May 29, 2001
NG-01-0721

Subject: Duane Arnold Energy Center
Docket No: 50-331
Op. License No: DPR-49
Response to Request for Additional Information (RAI) to Technical
Specification Change Request TSCR-042 – Extended Power Uprate. (TAC
MB0543)
Reference: NG-01-0660, “Response to Request for Additional Information (RAI) to
Technical Specification Change Request TSCR-042 – Extended Power
Uprate. (TAC # MB0543),” dated May 11, 2001.
File: A-117, SPF-189

Redacted Version of
DAEC Responses to NRC
Containment Systems Branch
Request for Additional Information
Regarding Proposed Amendment for Power Uprate

Figure 1: Containment Pressure Response For Short-Term DBA LOCA

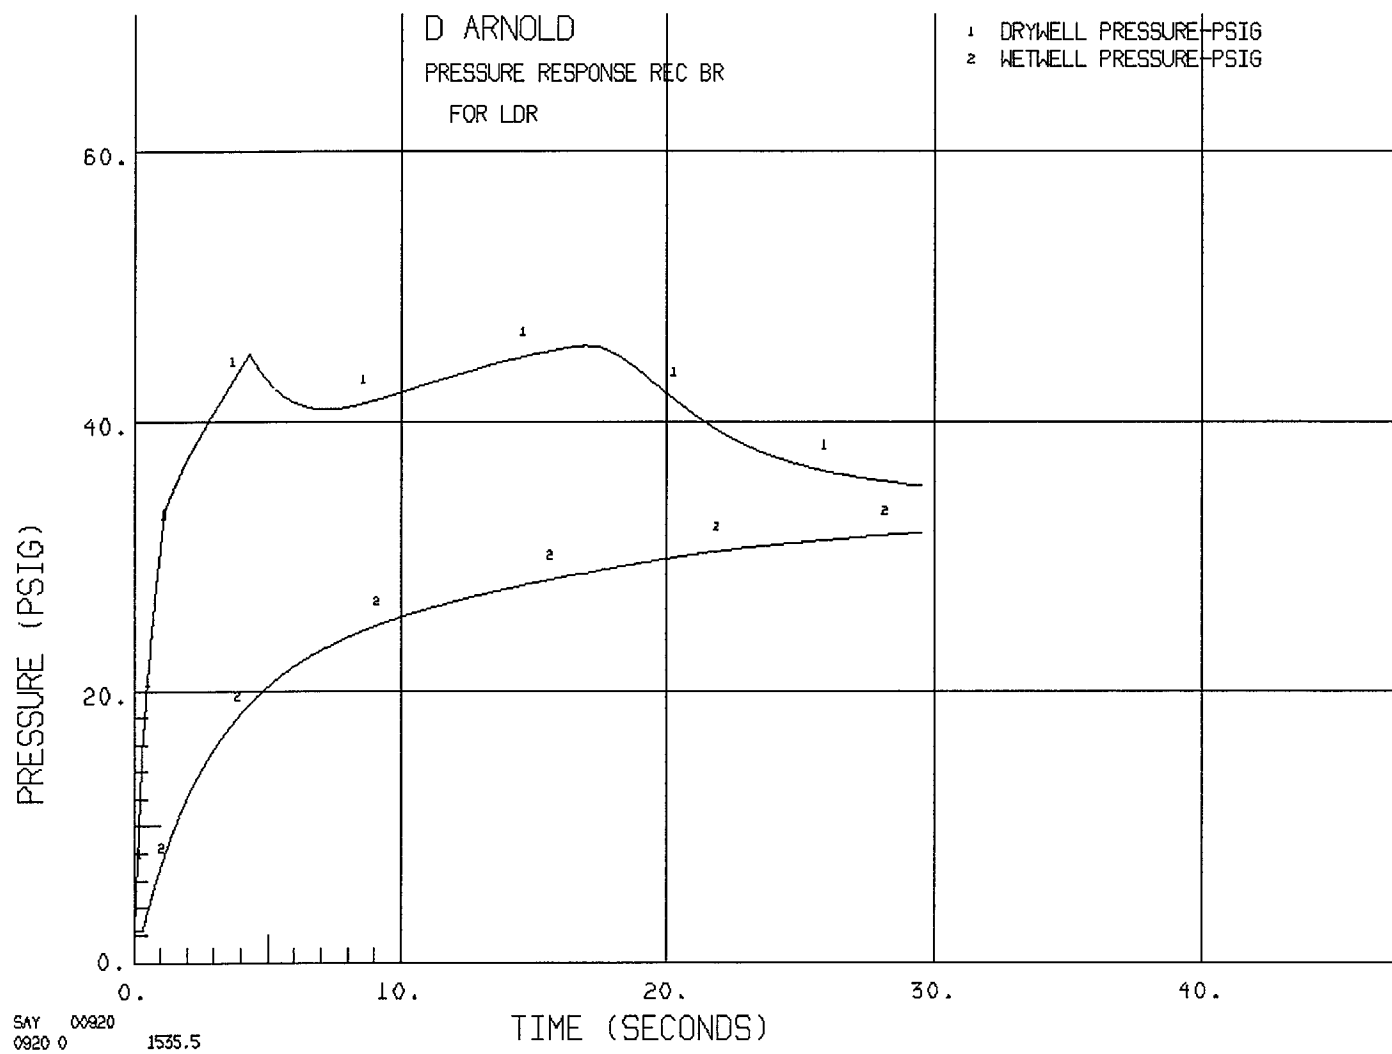
3. Provide short term and long term results (curves or tables of calculated values as a function of time) of Duane Arnold calculations for:

- (A) drywell short term pressure and temperature,
- (B) suppression pool short term temperature
- (C) wetwell atmosphere short term pressure and temperature
- (D) suppression pool long term temperature
- (E) wetwell atmosphere long term pressure and temperature

- (A) Short-term drywell pressure – Figure 1
Short-term drywell temperature – Figure 2
- (B) Short-term suppression pool temperature – Figure 2*
- (C) Short-term wetwell atmosphere pressure – Figure 1
Short-term wetwell atmosphere temperature – Figure 2*

Figure 6: Containment Pressure Response For Long-Term NPSH

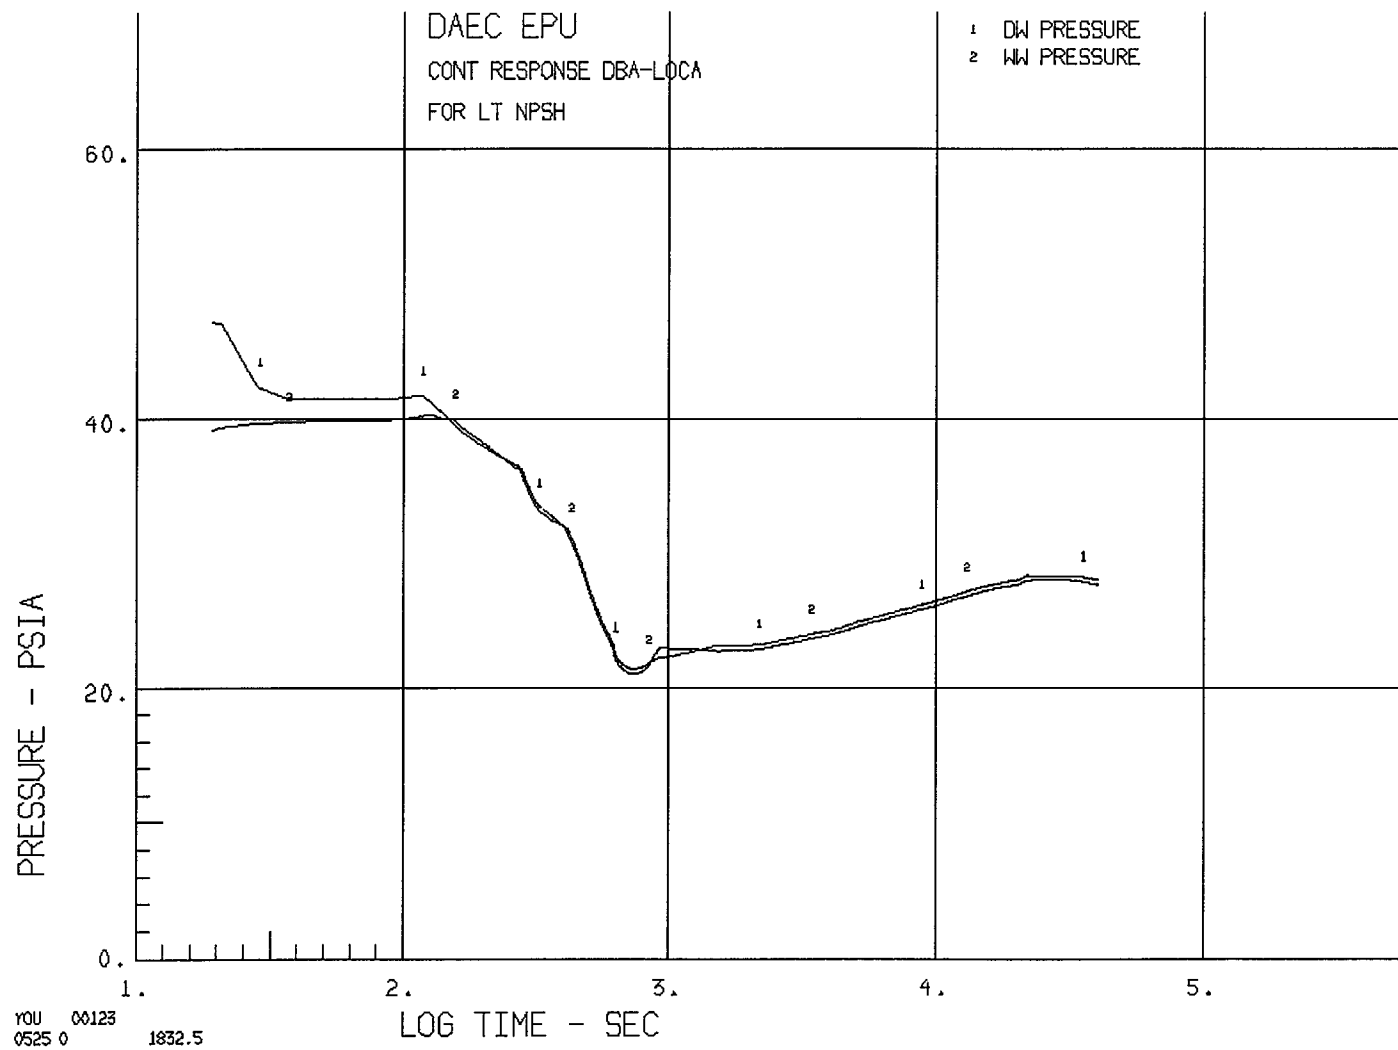
If the long term calculation results are different from those used for calculating NPSH, provide the suppression pool long term temperature and wetwell atmosphere long term pressure and temperature used for the NPSH calculation.

- (D) Long-term suppression pool temperature:
 - DBA-LOCA - Figure 5
 - NPSH - Figure 8
- (E) Long-term wetwell atmosphere pressure
 - DBA-LOCA - Figure 3
 - NPSH – Figure 6

Figure 9: Containment Pressure Response For 0.01 ft² Steam Line Break

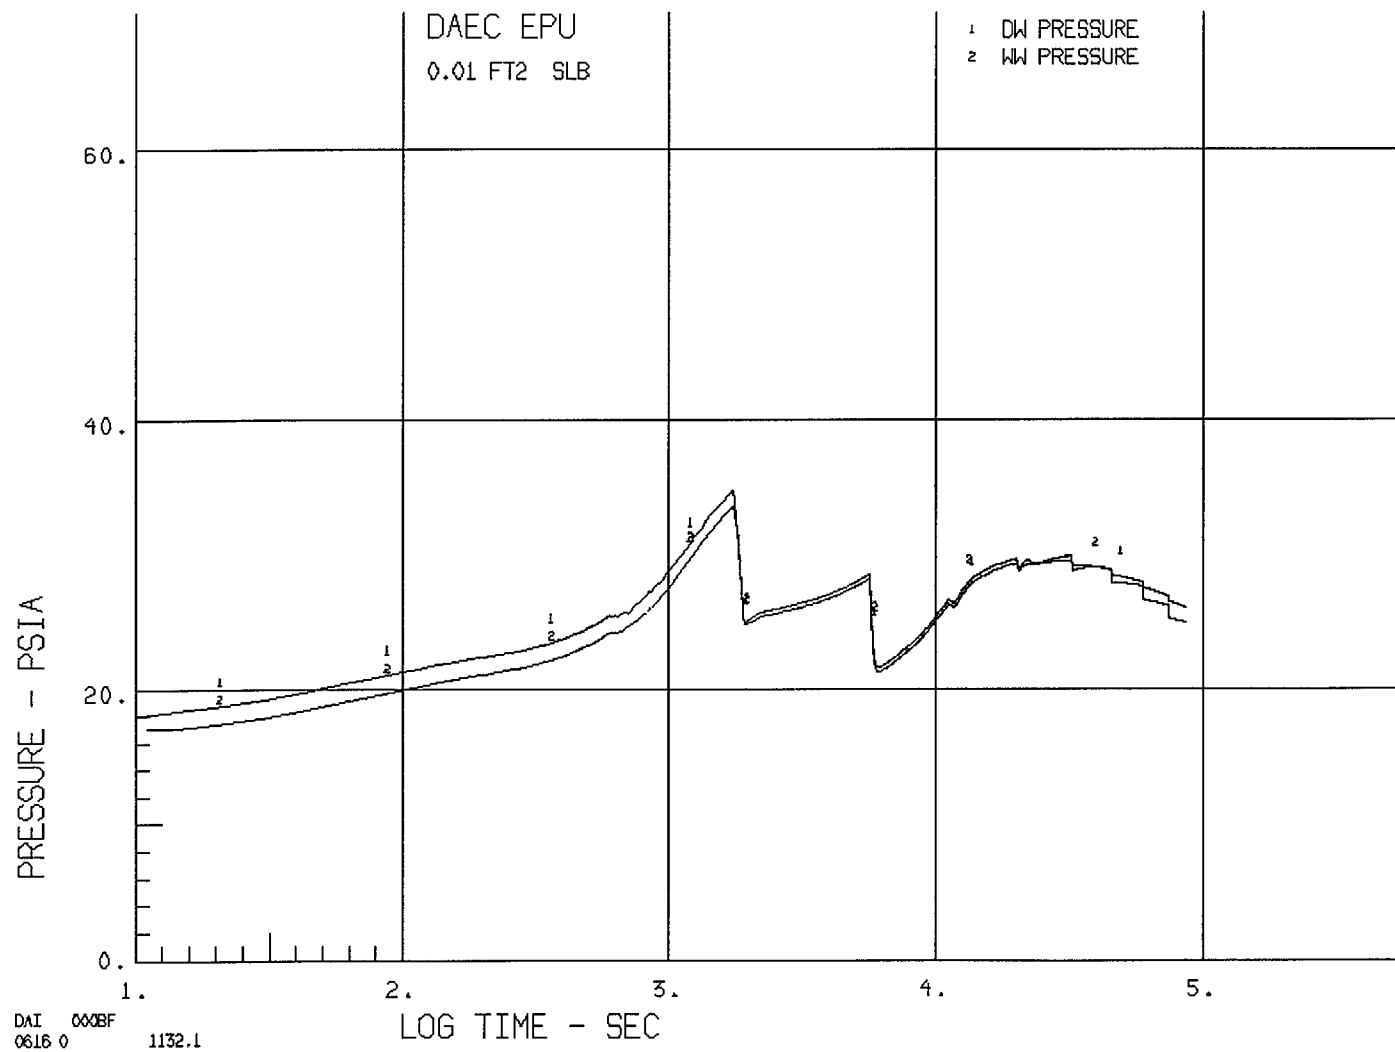
7. Describe the steam line break scenario which requires calculating a 120 day containment response. Describe in more detail the calculation which is done for this scenario or provide the calculation.

In addition, based upon the conference call with the Staff, a representative main steamline break should be included in the data request. Consequently, we are also providing the following figures of the results of that analysis:

- (F) Drywell and wetwell atmosphere pressure – Figure 9
Short-term Drywell temperature – Figure 10
Long-term Drywell temperature – Figure 11
Wetwell atmosphere temperature – Figure 12
Suppression Pool temperature – Figure 13
